CR comment discussion

IEEE P802.3ck Task Force

April 22, 2020

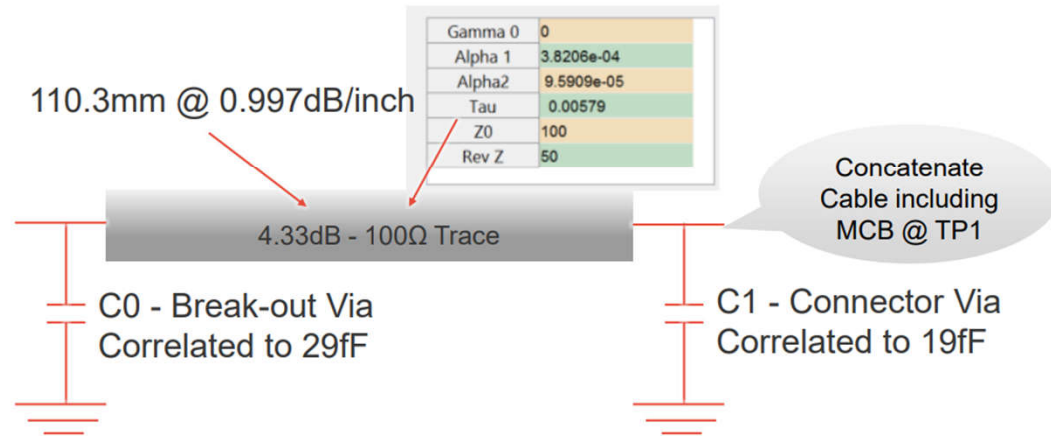
This DFE floating tap tail root-sum-of-squares limit is 0.03. For the worst of 7 borderline channels in kasapi_3ck_01_1119 slide 12 (kareti1, OACH4, which is an outlier and probably should not be supported), the value is 0.022. Even for this channel with the most unlucky combination of package lengths including out-of-scope ones, it's <= 0.025 (slide 13). We should not encourage even worse channels than this, such as the failing channels on slides 16-17, and we should not indulge this one so much.

Remember that this parameter isn't a hard pass-fail limit; channels can exceed this but don't get a free pass for the excess ISI noise that they cause.
Change 0.03 to 0.02.

ACCEPT IN PRINCIPLE.

Based upon the result of strawpoll #12, implement the suggested remedy.

I support closing comment #152 using the suggested remedy.

Yes: 13

No: 3
